2014 Guidelines

The Cure for the Common Code

Academy of Architecture for Health

***For 84 proposed changes now
being considered by FGI***

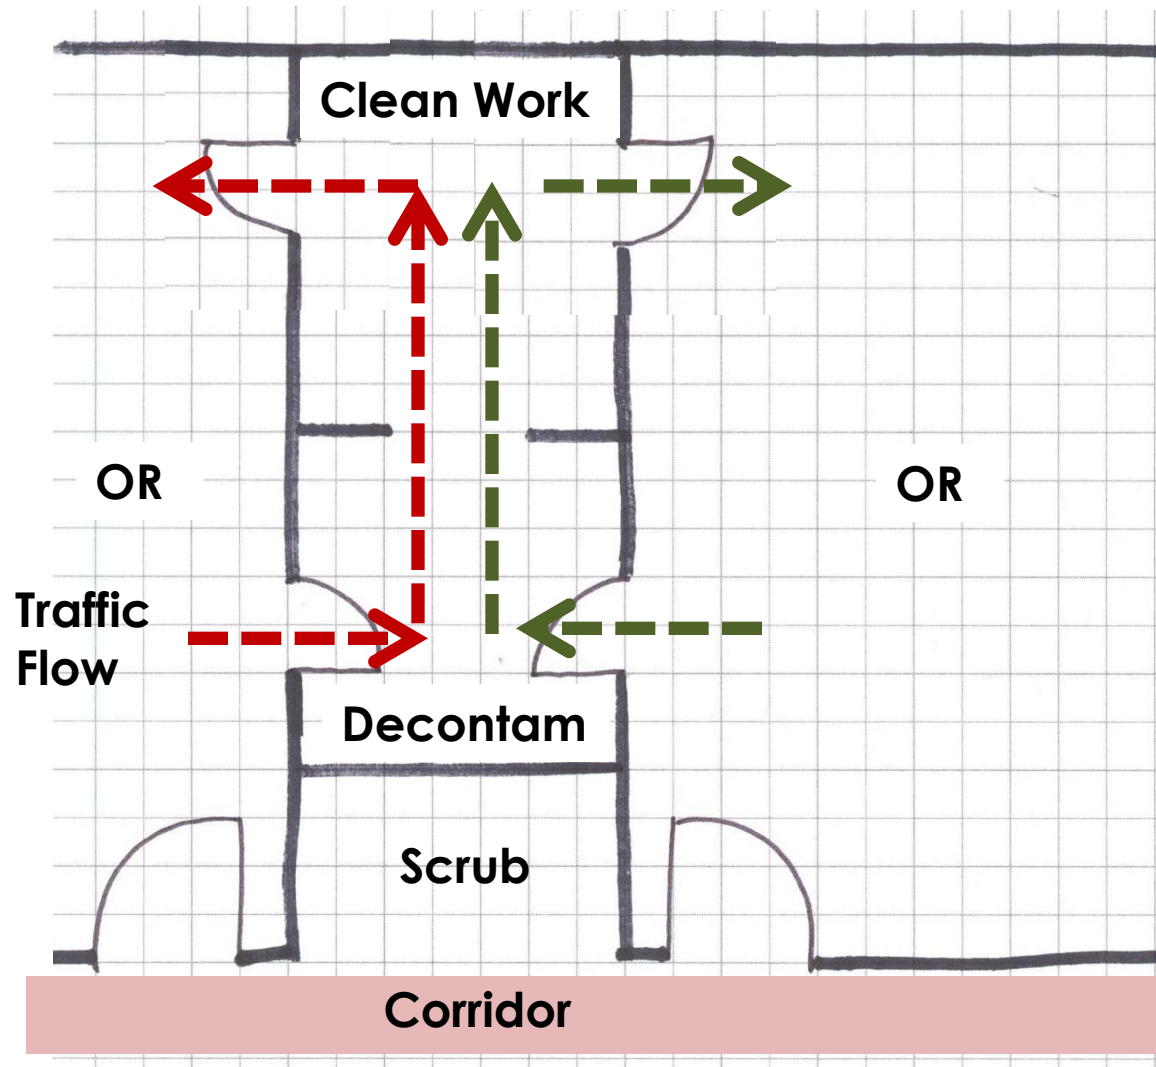
One - way traffic flow of '*dirty*' to '*clean*' materials/instruments is similar to the cleaning/sterilization flow/process in Central Services or Respiratory Therapy.

- ❖ Supported by AORN & Infection Control - HGRC
- ❖ Significant conceptual change to OR design
- ❖ Provide the same process in OP Surgery

REJECT & ACCEPT WITH AAH CHANGES

Scrub
Sink

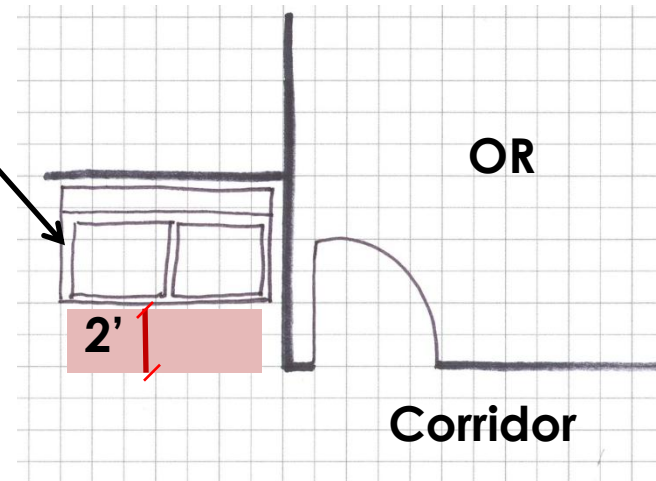
scrub sinks - located out of main traffic areas

if in an alcove, the alcove no less than 2 ft deeper than sink.

❖ This proposal is in multiple locations throughout Guidelines –
OP Surgery, Endo, OP Endo, Cath Lab...

ACCEPT

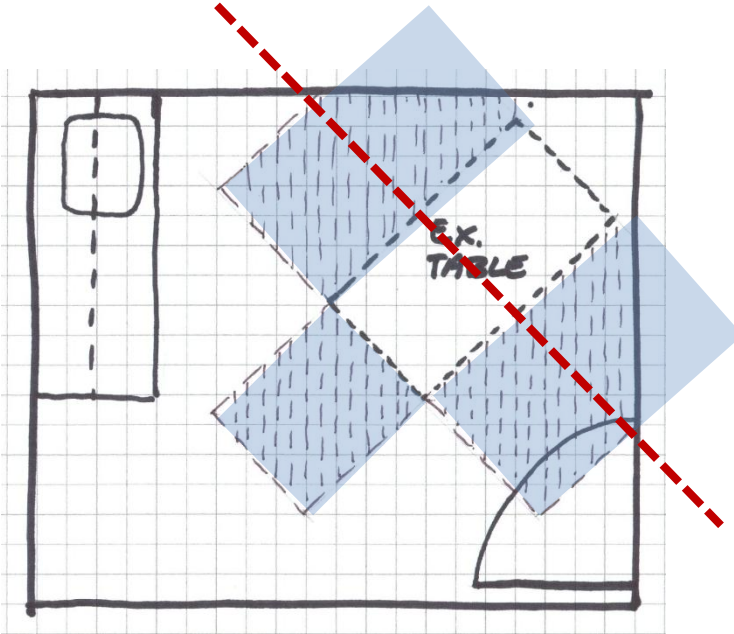
Room arrangement shall permit a min. clear dim. of **2' – 8"** at each side & foot of the exam table, recliner, or chair.

❖ **Option A: 2' – 8"**

clearance halfway down the length of exam table

❖ **Option B: 2' – 8"**

clearance down the entire length of exam table

YOU MAKE THE 'CALL'....

Exam Rm – 80sf 'clear'
area

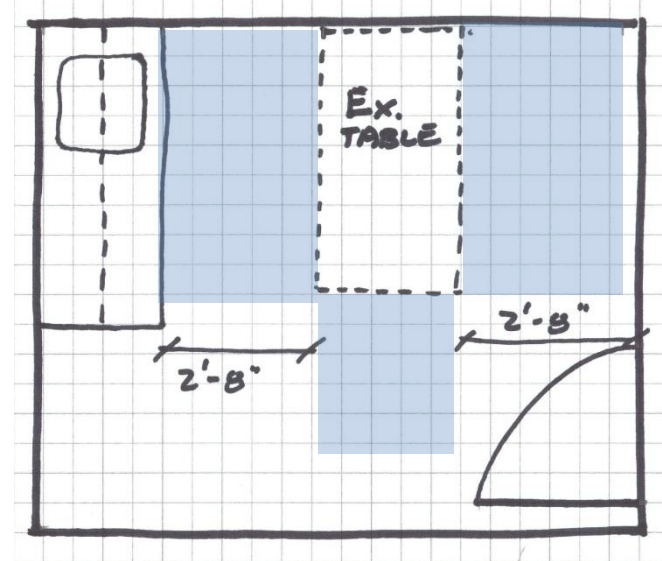
Option A

clearance halfway
down the length of
exam table

Option B

clearance down the
entire length of exam
table

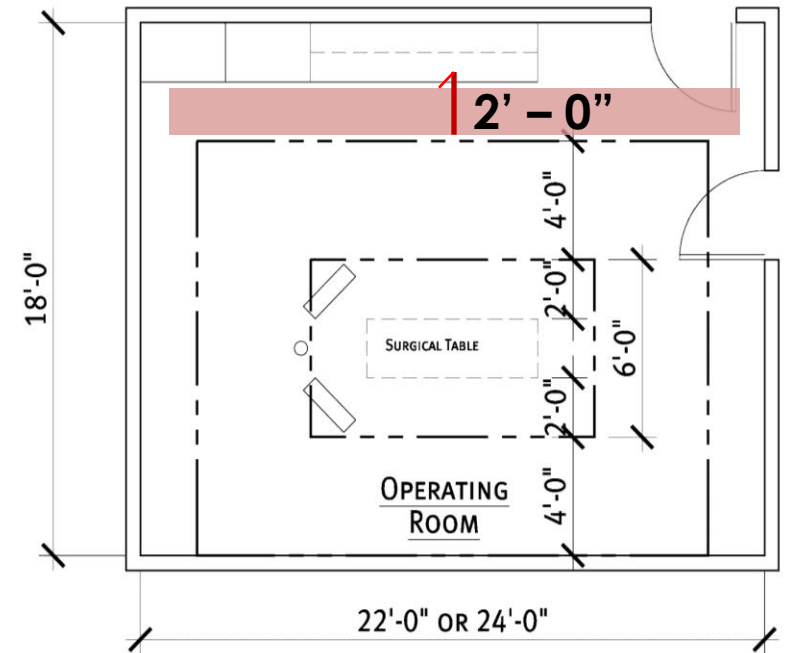
In new construction & renovation,
min clear floor area of 360 sf,
min clear dimension of ~~18~~ 16 ft

- ❖ Is this 'OR' of 360sf OK...???
- ❖ AAH proposed change - 18' to 16'
- ❖ Current 'Class C' - 400 sf & min. clear dimension of 18 ft and is also the current minimum for renovated Hospital OR's...

- 1) ACCEPT 'OR' SF
- 2) ACCEPT W/AAH CLEAR DIMENSION

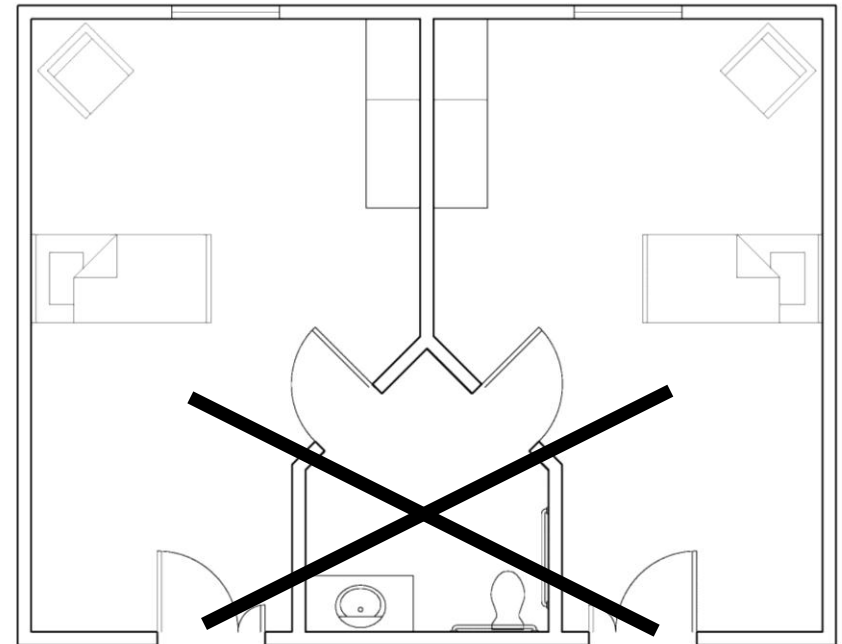
The patient toilet room shall serve no more than

~~two~~ one patient rooms and no more than two ~~four~~ beds

❖ Infection control & patient safety issue.....

❖ Eliminates the 'shared' patient toilet between 2 patient rooms

ACCEPT

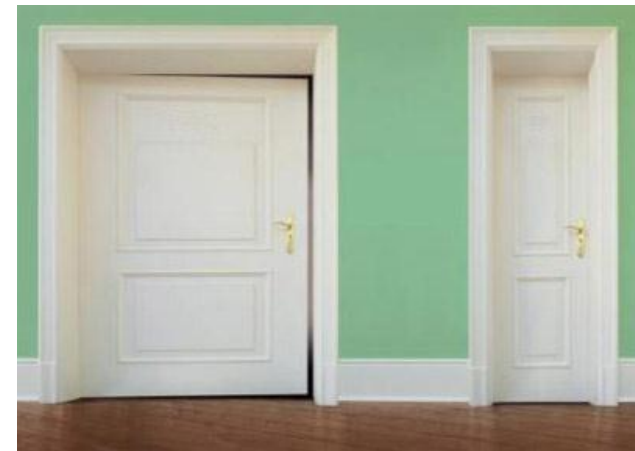
(2) **bariatric patient rooms –**

Min. clear width/height of **4' – 6" x 7'**

(3) **bariatric inpatient toilet rooms –**

Min. clear width/height of **3' – 8" x 7'**
